# Access Compliance Report

## Public Rights-of-Way

Intersection ID: 13151	Main Street: MERRIMAN_AV	Cross Street: SPRUCE_ST	Location: NW
ADA ID: C8B16E548AF0	Ramp Type: BlendTrans2	Initial Pass/Fail: Fail	Overall Compliance: No
		Severity Score: 10

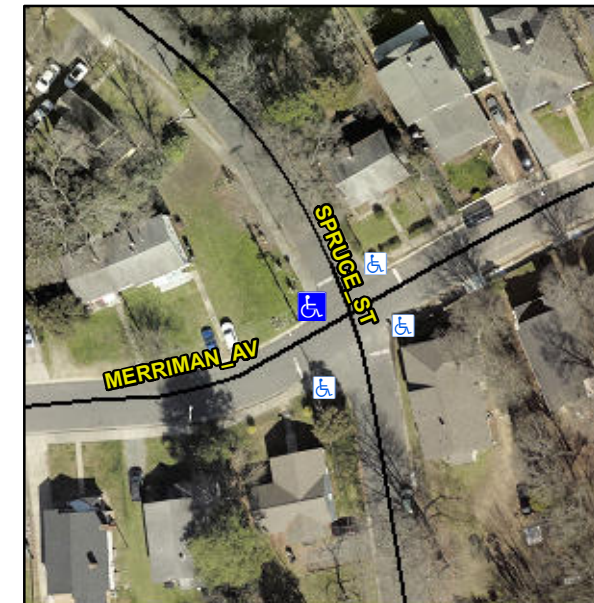
**Not Found, R304.5.1, R304.5.3**

Compliance	Description	Data	Compliance	Description	Data
N/A	Ramp Length (in)	60.0	Yes	BlendTrans Slope (%)	2.1
No	Ramp Width (in)	37.0	No	BlendTrans XSlope (%)	4.2
N/A	Flare Type LT	N/A	N/A	Flare Type RT	N/A
N/A	Flare Slope LT (%)	N/A	N/A	Flare Slope RT (%)	N/A
N/A	Flare Traversable LT?	N/A	N/A	Flare Traversable RT?	N/A
N/A	Landing Length (in)	N/A	N/A	DWS Provided?	N/A
N/A	Landing Width (in)	N/A	N/A	DWS Contrast?	N/A
N/A	Landing Slope (%)	N/A	N/A	DWS Length (in)	N/A
N/A	Landing X Slope (%)	N/A	N/A	DWS Full Width?	N/A
N/A	Landing Curb? (Y/N)	N/A	N/A	DWS Offset (in)	N/A
N/A	Shared Landing?	N/A			
N/A	Gutter Ponding?	N/A	N/A	Gutter Slope (%)	N/A
N/A	Gutter Lip Ht (in)	N/A	N/A	Gutter X Slope (%)	N/A
N/A	Painted X Walk1?	No	N/A	Painted X Walk2?	No
	X Walk 1 Direction	To SE		X Walk 2 Direction	To NE
	X Walk 1 Width (in)	N/A		X Walk 2 Width (in)	N/A
	X Walk 1 Slope (%)	3.0		X Walk 2 Slope (%)	0.6
	X Walk 1 X Slope (%)	2.0		X Walk 2 X Slope (%)	9.1

N/A	Ramp inside XWalk1?	N/A	N/A	Ramp inside XWalk2?	N/A
	Road Slope (%)	0.6		Clear Space?	N/A
	Road X Slope (%)	5.0	N/A	Clear Space to XWalk (in)	N/A
N/A	Any Obstructions?	N/A	N/A	Storm Grate/Utility Hazard?	N/A
	Obstruction Type			Storm Grate/Utility Type	
		N/A			N/A
			Yes	Surface Condition? (G/P)	Good
			No	Curb Slope (%)	17.2

**Remove & Replace Curb Ramp With Two New Directional Ramps or Equivalent.**
